BOARD OF ADJUSTMENT CASE REPORT

BOA-23159

LOCATION: 1518 S NORFOLK AV E

ZONING CLEARANCE PLAN REVIEW

ISSUED: PERMIT SET
 DATE: 15 MAY 2021
 SCALE: As indicated
 SHEET NAME: COVER SHEET & SITE PLAN
 SHEET NUMBER: A-001

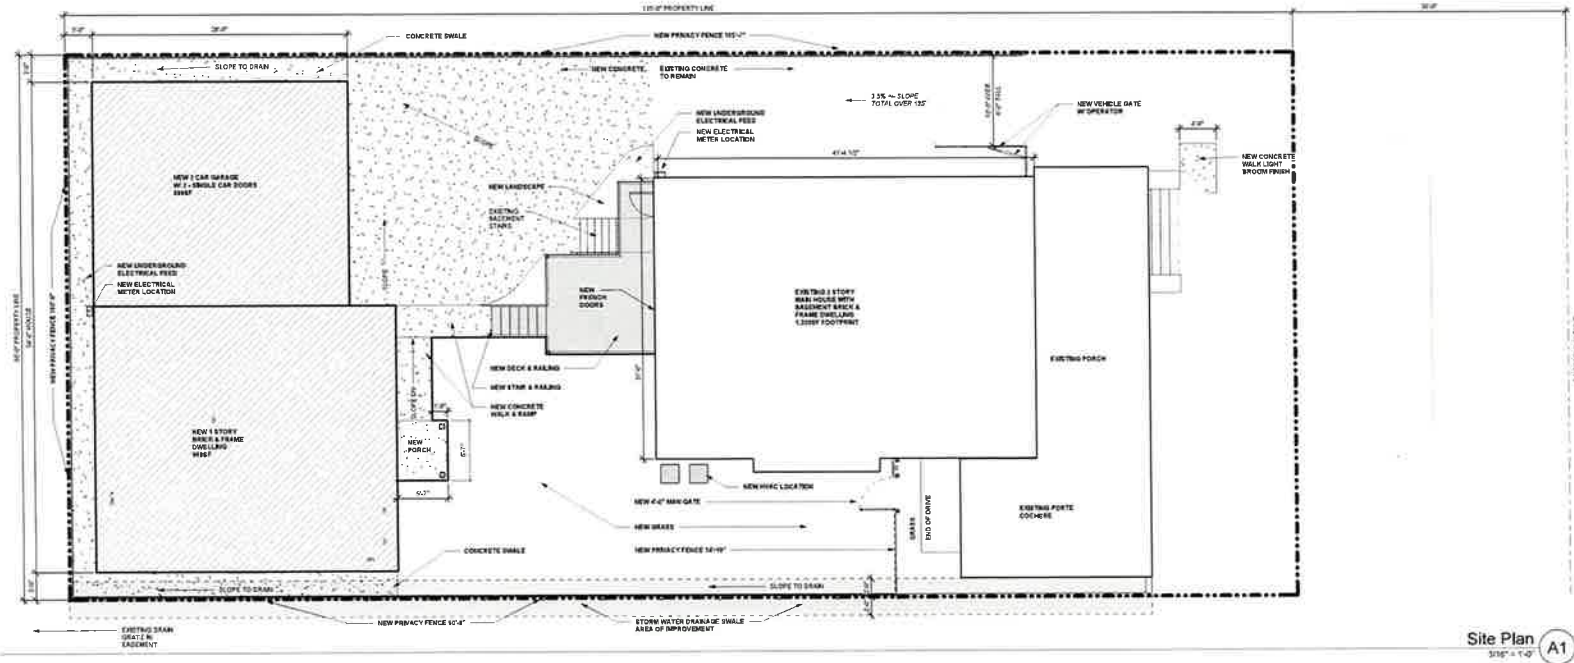
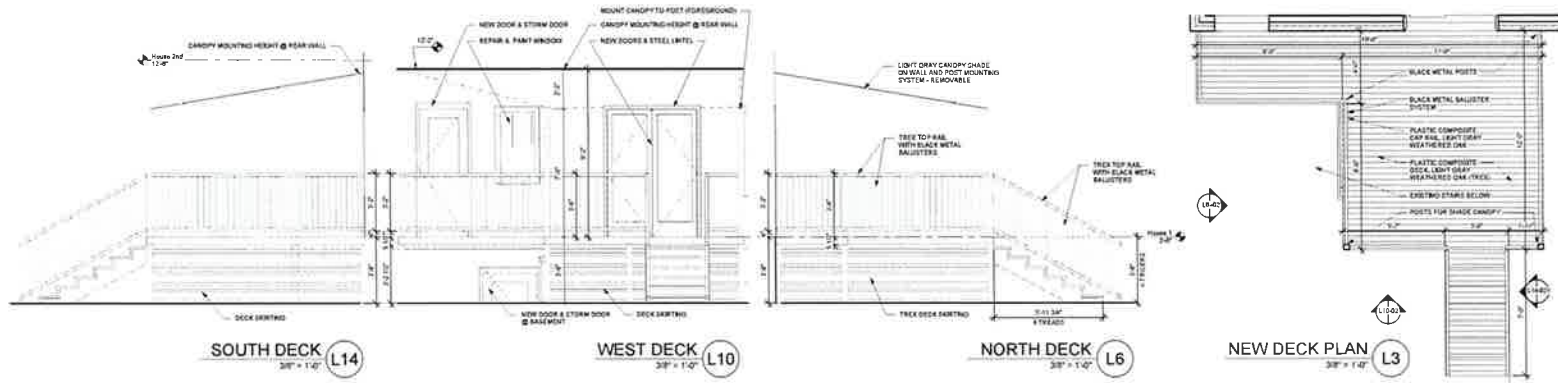
1. Site plan must include dimensions of all buildings and drives. Resubmit plan with attached information and review will continue.

The proposed property exceeds 30% in the rear
setback. Reuse plan to meet requirement or
seek variance from the Board of Adjustment.

6, Sec 45.080 A - Fences and walls within required building setbacks may not exceed 8 feet in height, except in required street setbacks fences may not exceed four feet in height. Review Comment: Revise plan to meet requirements or seek a variance from the Board of Adjustment.
